Hall County Government
COMMUNITY DEVELOPMENT AND INFRASTRUCTURE
PUBLIC WORKS AND UTILITIES

MEMORANDUM

Subject: Danji Site Development Traffic Impact Study – White Sulphur Road

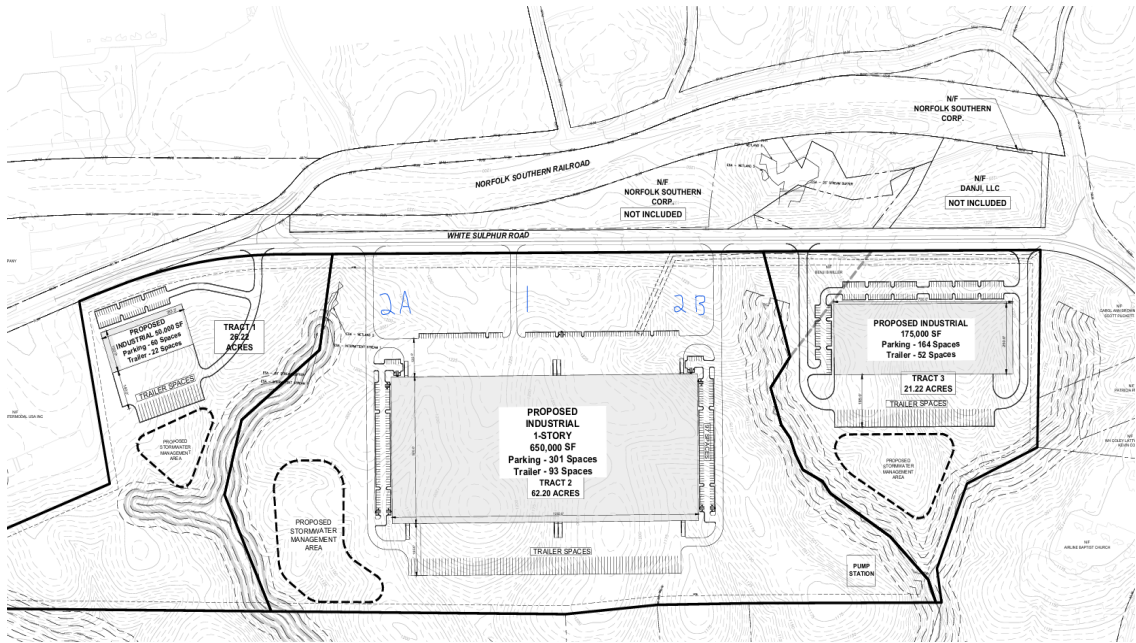
Tract 2 – based on the narrative on page 13, Tract 2 concerning the necessity to separate employee and truck traffic, two total driveways, for a total of 3 driveway cuts, are recommended, operating as follows:

- . One driveway for employee parking (labeled 1)
- . One entrance only for truck traffic (labeled 2A)
- . One exit only for truck traffic (labeled 2B)

Additionally, the site plan shows employee parking in the front and along the sides of the building but accessing the truck entrance driveways only. To support the narrative, all passenger vehicle parking on the side of the building must be accessed from the employee entrance only.

It is also recommended to require the construction of a right-turn lane for driveway 1 and 2A. The appropriate design criteria for a 35 MPH roadway are shown in the GDOT Regulations for Driveway and Encroachment Control Manual, table 4-8 (shown below):

Additionally, the radii for driveways 2A & 2B should be 75' to accommodate truck turning movements.
